UNITED STATES PATENT AND TRADEMARK OFFICE

APPLICATION NO.	FILING DATE	FIRST NAMED INVENTOR	ATTORNEY DOCKET NO.	CONFIRMATION NO.
10/591,084	03/26/2007	Cesar Astiz Montoya	2004P00286WOUS	7830

Office Action Summary	Application No. 10/591,084	Applicant(s) ASTIZ MONTOYA ET AL.	
	Examiner JORGE PEREIRO	Art Unit 3749

DETAILED ACTION

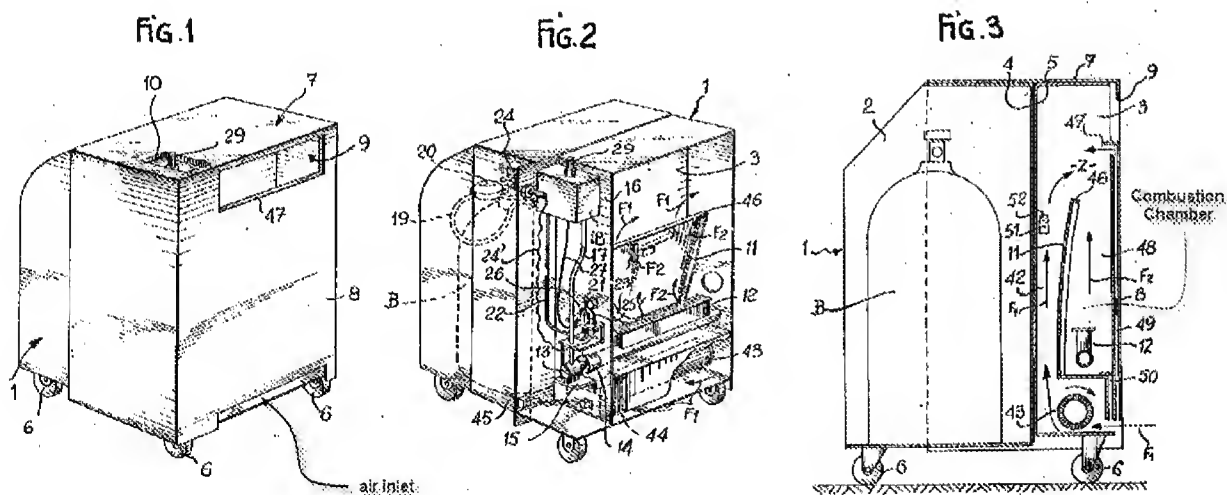
4. In re claim 27, with reference to figures 1-3 below, Antargaz discloses a gas heating device (1) comprising: a gas burner (12) including a combustion chamber (referenced in figure 3

below) for the flames of the gas burner; and a convection air conduit (3) including an air outlet (9) evacuating a convection air stream (F1, F2) that has been heated in the gas heating device, the combustion chamber of the gas burner being in fluid-flow communication with the convection air conduit and mixing an exhaust gas stream from the combustion chamber with the convection air stream.

5. In re claim 28, with reference to figures 1-3 above, Antargaz discloses all of the claim limitations including wherein the gas burner (12) is located inside the convection air conduit (3).

6. In re claim 29, with reference to figures 1-3 above, Antargaz discloses all of the claim limitations including wherein the convection air conduit (3) includes a first air duct (48) and a second air duct (42).

7. In re claim 30, with reference to figures 1-3 above, Antargaz discloses all of the claim limitations including wherein the gas burner (12) faces the first air duct (48).

8. In re claim 31, with reference to figures 1-3 above, Antargaz discloses all of the claim limitations including wherein the second air duct (42) is located behind the gas burner (12).

9. In re claim 32, with reference to figures 1-3 above, Antargaz discloses all of the claim limitations including wherein a control element (52) is located in the second air duct (42).

10. In re claim 33, with reference to figures 1-3 above, Antargaz discloses all of the claim limitations including wherein at least one swirling element (46) is arranged in the air duct (48) which adjusts a residence time of secondary air in the area of the gas burner (12).

11. In re claim 34, Antargaz discloses all of the claim limitations including wherein the swirling element (46) at least partially surrounds the gas burner (12) in a funnel shape (see figures 2 and 3 above).

12. In re claim 35, with reference to figures 1-3 above, Antargaz discloses all of the claim limitations including wherein the convection air conduit (3) is arranged substantially perpendicularly in the gas heating device.

13. In re claim 36, with reference to figures 1-3 above, Antargaz discloses all of the claim limitations including wherein the gas burner (12) comprises a burner plate including a plurality of flame outlet openings (see figure 2 above).

14. In re claim 37, with reference to figures 1-3 above, Antargaz discloses all of the claim limitations including wherein the convection air conduit (3) is at least partly defined by a heat-resistant, radiation-transmitting element (49).

15. In re claim 40, with reference to figures 1-3 above, Antargaz discloses all of the claim limitations including wherein at least one flow guiding element (11) is provided in the convection air conduit (3) protecting heat-sensitive locations (51, 52) of the gas heating device from the convection air stream (F2).

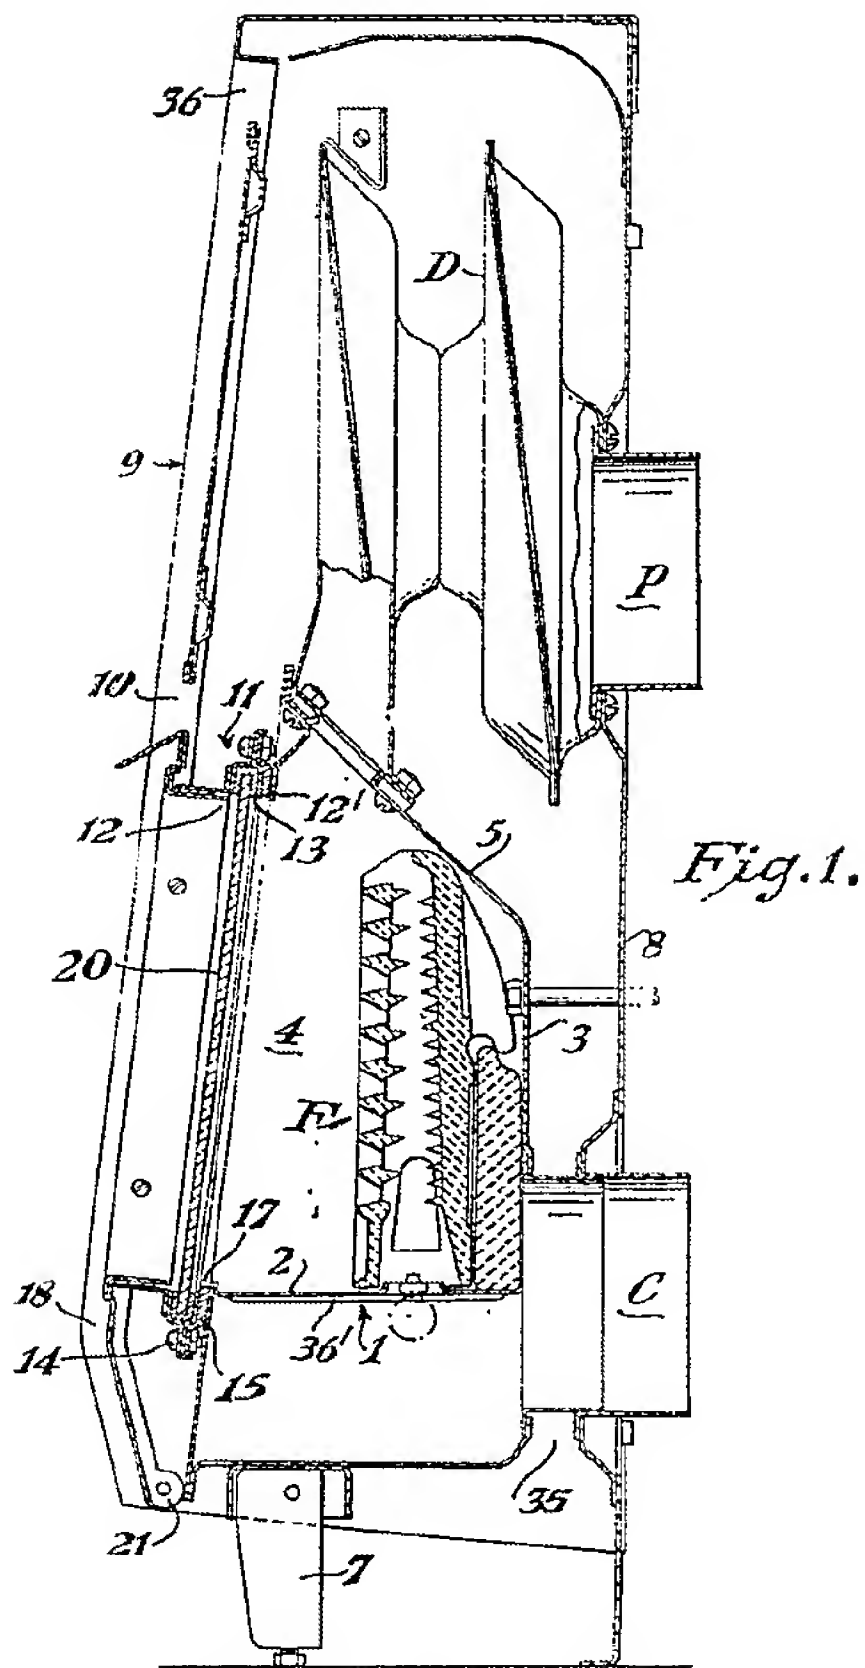
31. Nonetheless, with reference to figure 1 below, Fuidge discloses a gas space/room heater that heats by both radiation and convection wherein a radiation-transmitting element (20) is a square/rectangle formed from at least one of glass and glass ceramic (see page 2, lines 119-129).

36. In re claim 39, with reference to figure 1 of Fuidge above, Antargaz in view of Fuidge discloses all of the claim limitations including wherein the radiation-transmitting element (20) is located in a direction of thermal emission of the gas burner (F).

38. Nonetheless, with reference to figure 1 of Fuidge above, Fuidge discloses a gas space/room heater that heats by both radiation and convection wherein a window-like recess (12) is provided in the front housing portion (9) in the direction of thermal radiation of the gas burner (F).

40. In re claim 47, with reference to figure 1 of Fuidge above, Antargaz in view of Fuidge discloses all of the claim limitations including wherein the radiation window (12) of the front housing portion is closed by means of a radiation-transmitting square or rectangle (20).
